State of Alaska DOT&PF  
ALASKA STANDARD PLAN  
MASH BRIDGE RAIL  
THRIE BEAM TRANSITION

## STANDARD PLAN DEVELOPMENT REPORT (SPDR)

Standard Plan No.: G-32.04

Title: MASH Bridge Rail Thrie Beam Transition

THRIE BEAM STEEL BLOCKOUT - SHORT

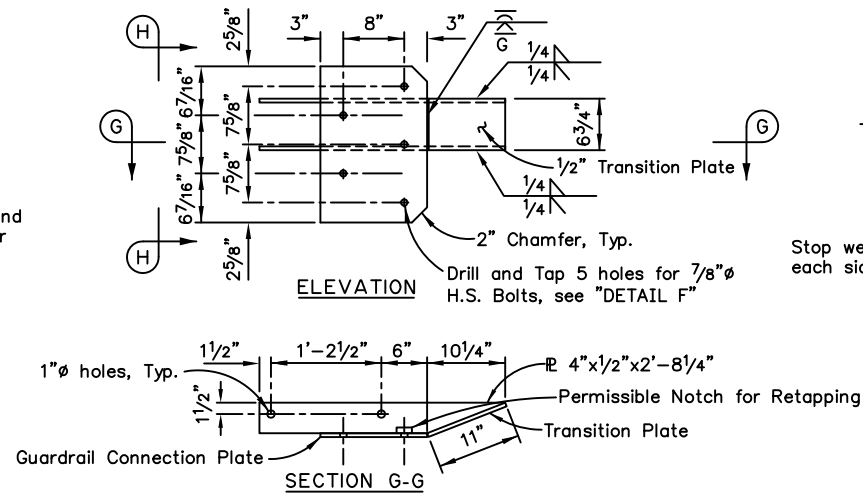
- “1 – 5/8 x 1 ½” Hex Bolt on top” and “1 – 1’-2” Guardrail Bolt on bottom” was added to the Thrie Beam Steel Blockout – Short detail, and lines indicating such bolts were added, for clarity.

THRIE BEAM STEEL BLOCKOUT - LONG

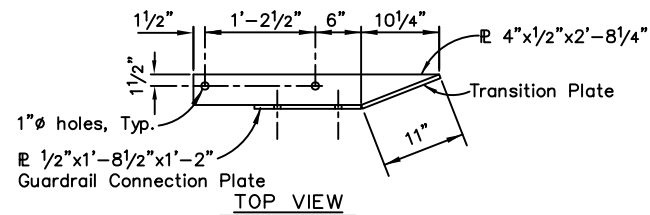
- “W6x9 Post” callouts were changed to “W6x8.5 Post” for all posts.
- “2 – 1’-2” Guardrail Bolts” was added to the Thrie Beam Steel Blockout – Long detail for clarity.

GUARDRAIL CONNECTION PLATE DETAILS

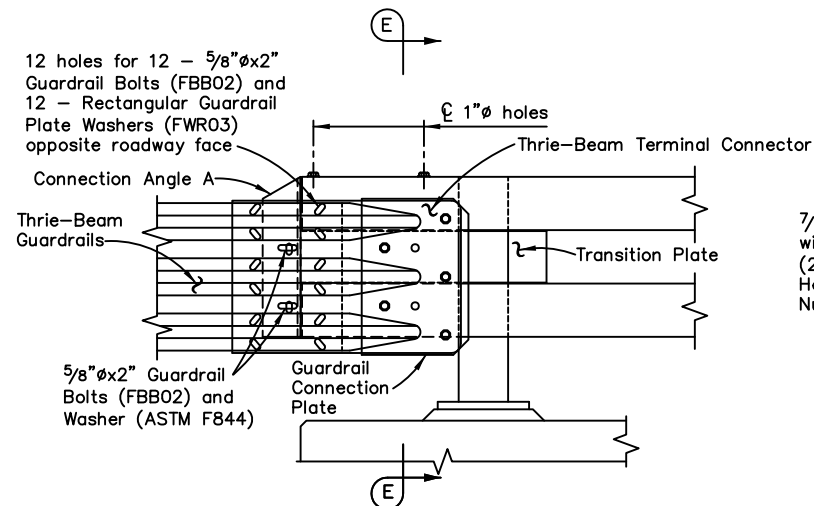
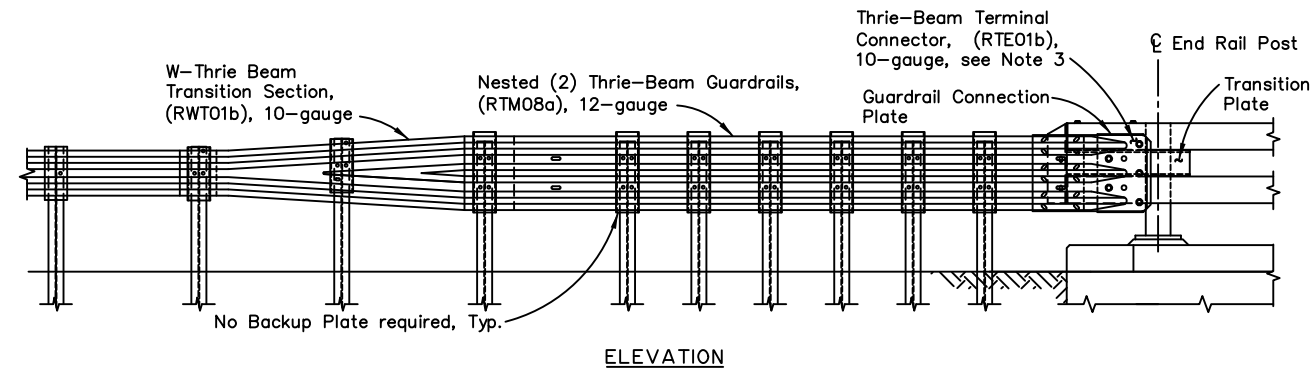
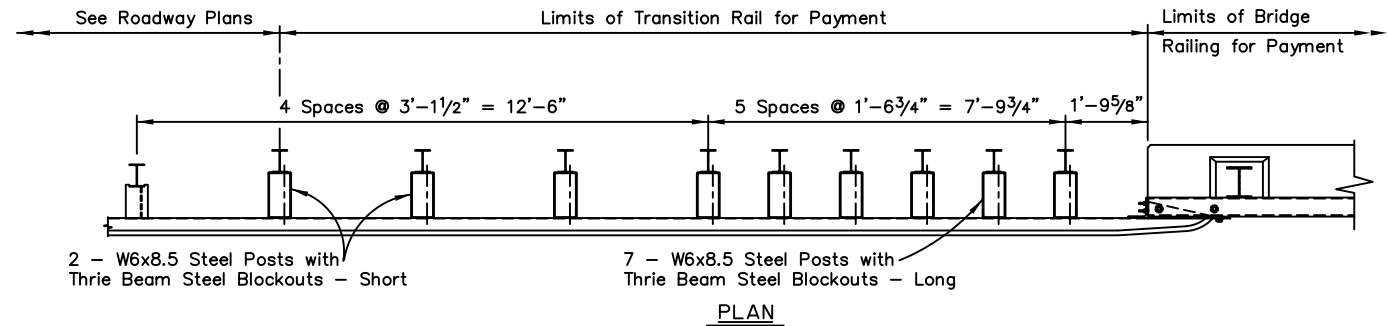
- The callout for the “Transition Plate” was changed to “1/2” Transition Plate” on the Elevation detail of the Guardrail Connection Plate Details.
- “Alternate 2” was deleted from all the Thrie-Beam Terminal Connector callouts and details were changed to show the Thrie-Beam Terminal Connector drawn as Alternate 1.
